Department of Environmental Protection

OCD-SW-00-0555

Orange County - SW
Keene Road Disposal/Buttrey Development
Class III Landfill - Construct & Operate
Permit Application Nos. SC48-0165969-001 and SO48-0165969-002

SUBJECT: Buttrey Development Project
Deflection Liner Installation Plan
Revised November 16, 2000

DATE	
SCALE	
DRAWN BY	EC
CHECK BY	EC
REVISIONS	
1	MAY 2000 FDEP
2	
3	
4	
5	
6	
7	
8	
9	
10	
MONITOR WELL LOCATIONS	
DRAWING NO. FIGURE 4

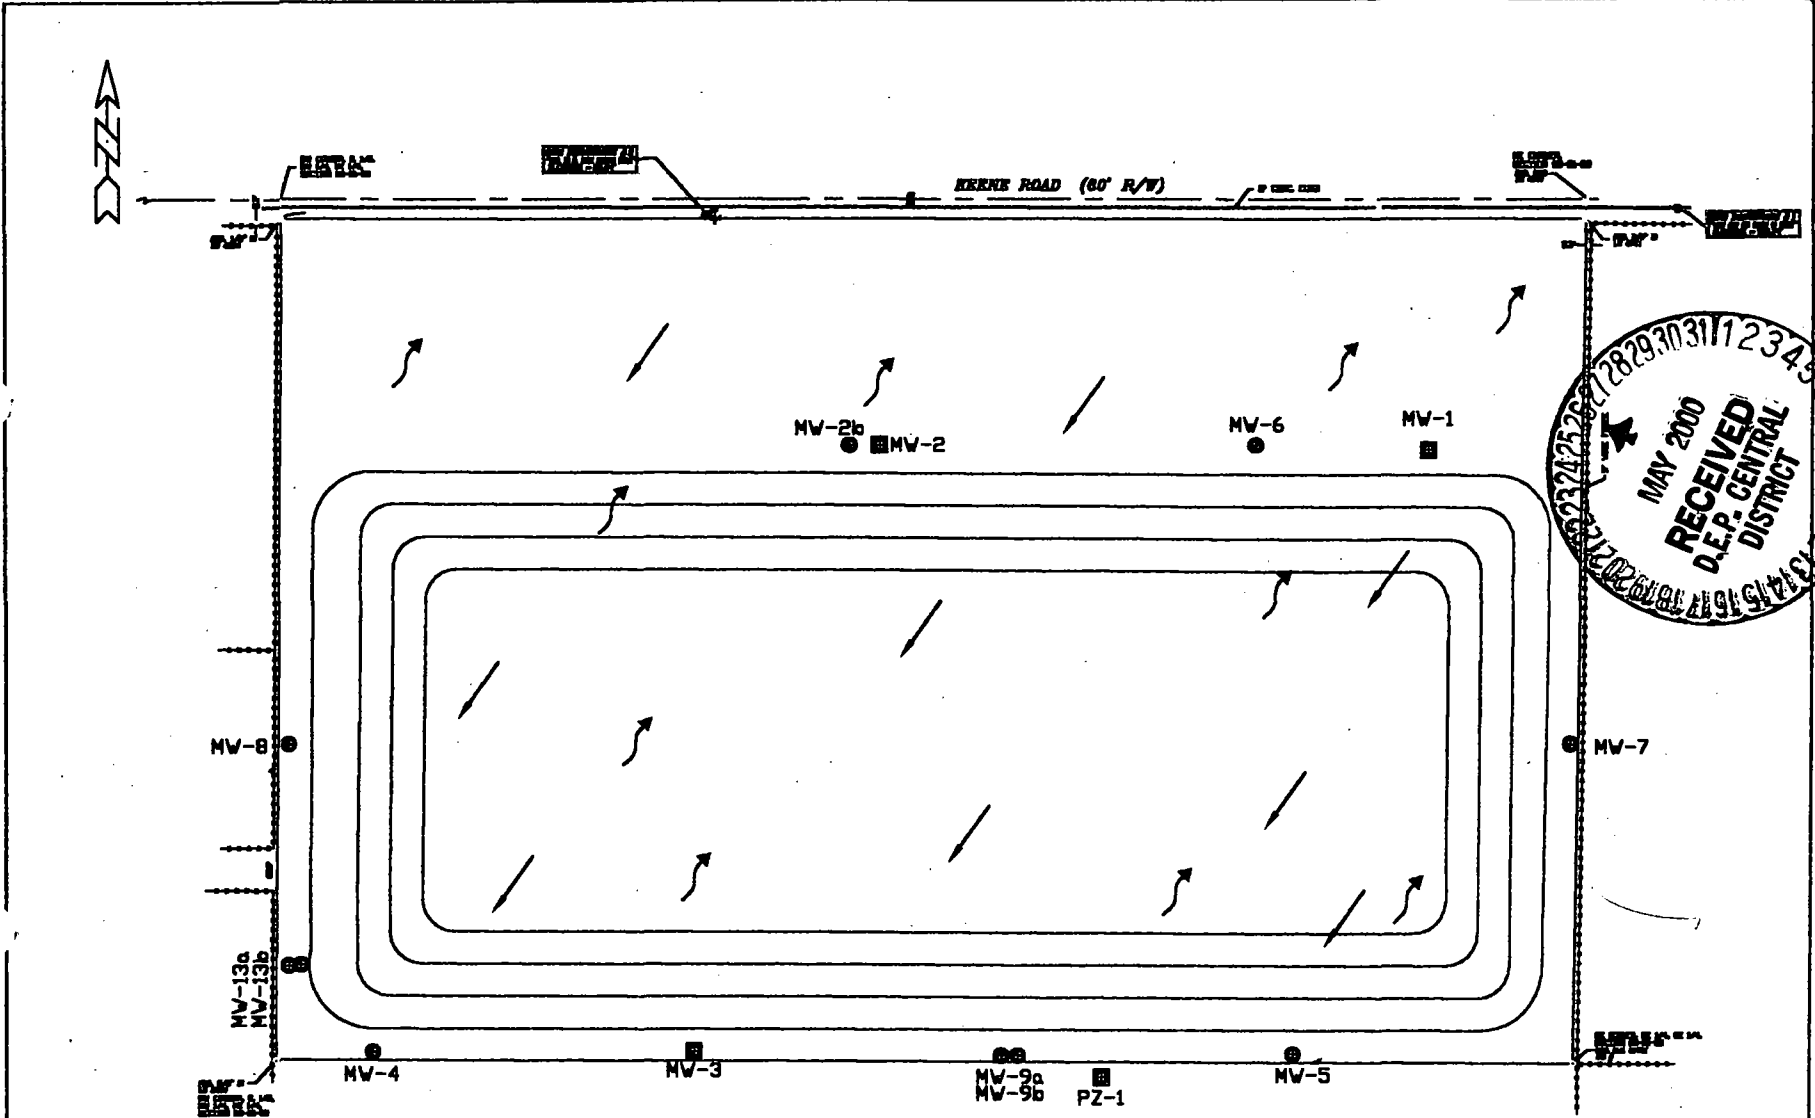
20. Figure 4 depicts the Floridan and surficial aquifer flow direction and the proposed monitoring well locations. Rule 62-701.510(3)(d)3 F.A.C. states "Well spacing shall be no greater than 500 feet apart across the downgradient direction of ground water flow." Therefore, an additional monitoring well location 500 feet east from monitoring well location MW-3 and 500 feet west from monitoring well location MW-5 is necessary. Additionally, the figure did not include a bar scale. Please revise Figure 4 accordingly.

4. Please submit on an IBM formatted diskette or CD-ROM the raw data logger data that was generated during the slug tests.
5. Figure 4 depicts the Floridan and surficial aquifer flow direction and the proposed monitoring well locations. Rule 62-701.510(3)(d)3 F.A.C. states "Well spacing shall be no greater than 500 feet apart across the downgradient direction of ground water flow." Therefore, an additional monitoring well location 500 feet east from monitoring well location MW-3 and 500 feet west from monitoring well location MW-5 is necessary. Additionally, the figure did not include a bar scale. Please revise Figure 4 accordingly.

20. A revised Figure 4 is attached as Exhibit N. Based on the recent field work and a better understanding of actual site conditions, the installation of Floridan wells at this site has been re-evaluated. This site exhibits continuous confining type soils beneath the proposed landfill footprint except for the two locations identified above. Considering the well documented and accepted regional flow data in this area (confirmed by adjacent Keene Road Landfill & the Orange County RIBS facility (our site is located between the two)) it is not desirable for us to penetrate our Floridan confining/semi-confining units, unless it is absolutely imperative. While you agree with and acknowledge the regional flow direction as being correct, your request for further confirmation is not referenced by any Rule of the F.A.C. or specific concerns.

It is my opinion that with the confining soils identified beneath this site, deep monitoring of the Floridan would not be beneficial. Considering the two areas identified on Figure 1 (Exhibit K), deeper surficial monitor wells (one installed downgradient and one upgradient of the landfill footprint) would provide the desired monitoring data, while satisfying the intent of the F.A.C. This approach is far more realistic than the deep Floridan wells proposed earlier. As a result, the original Floridan wells have been deleted from the monitoring plan and replaced by shallow & deep zone monitor wells in the surficial aquifer. The revised Figure 4 & Table 2 reflects these changes.
